Re: Delta HUB Cycling - Proposed 2018 Community Safety Enhancements

On behalf of the Delta HUB Cycling Committee, I am writing in response to your November 29, 2017 email requesting input on proposed cyclist enhancements.

Northbound entrance to Hwy 17 at Hwy 17A

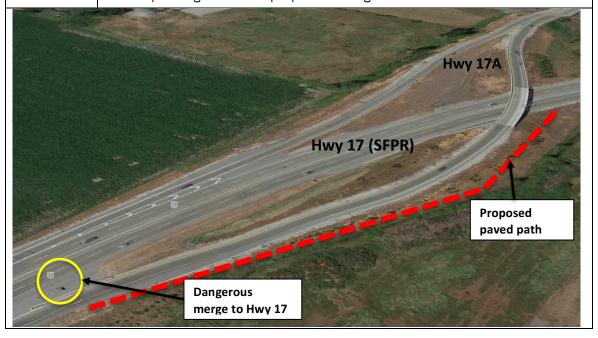
Cyclists continuing along Hwy 17 must cross busy entrance to Hwy 17A overpass. For safety, suggest that a new paved path be constructed from the Hwy 17 shoulder – along the lower part of the Hwy 17A overpass, on its eastern side - connecting with a new entry point to the SFPR. This would complement the new paved paths that MoTI implemented (to 64 St/28 Ave) in conjunction with the nearby Truck Staging Facility, to avoid a similarly hazardous merge for southbound cyclists. For illustration, a simple diagram of the proposed change can be found below:
